# UNITED STATES PATENT AND TRADEMARK OFFICE

<b>Office Action Summary</b>	<b>Application No.</b> 10/525,251	<b>Applicant(s)</b> PERRIN, RICHARD	
	<b>Examiner</b> HELENA KOSANOVIC	<b>Art Unit</b> 3749

## DETAILED ACTION

(fig. 3, of Magill)

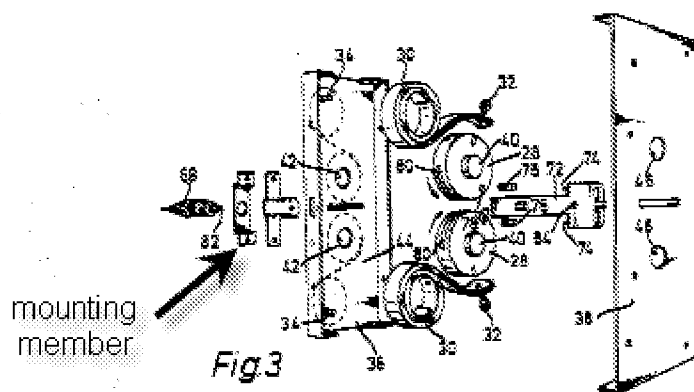
Regarding claim 47, the body member comprises a cylindrical casing (86) mounted by a holder (fig. 3, see paragraph below where the examiner labeled originally not labeled element with darkened arrow), said opening in the exterior of the body member being in the holder.

Regarding claim 52, the casing has a recess (see paragraph below where the examiner labeled originally not labeled elements for clarification with darkened arrows), the movable member is within the casing (figs. 9-11), and the actuating member has a detent (triangle part of element 70) engaging in the recess such that when the heat-softenable or meltable material is soft or molten, a force on the actuating member in a

3. The examiner labeled originally not labeled elements for clarification:

(fig. 9 of Magill)

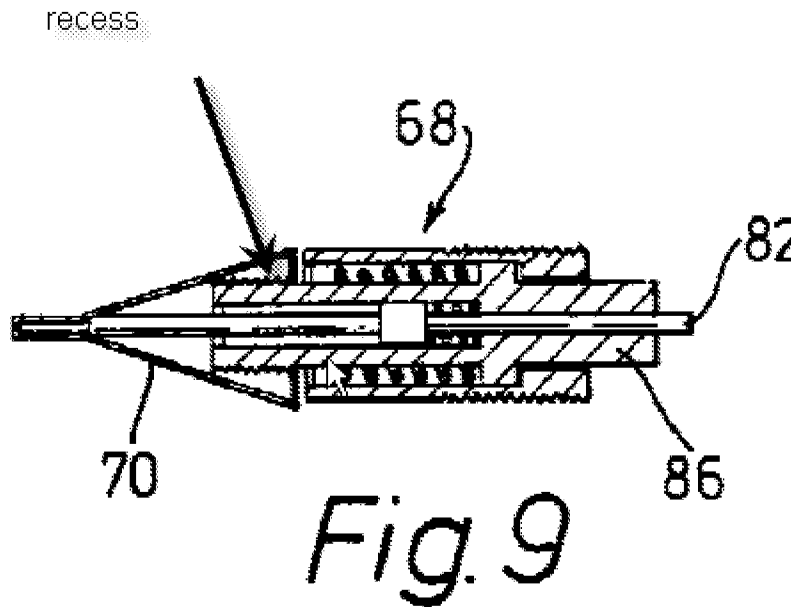
Regarding claim 48, body member 68 is extended, the temperature-sensitive element being adjacent one end of the body member and the opening in the exterior of the body member being adjacent the other end of the body member (fig. 9).
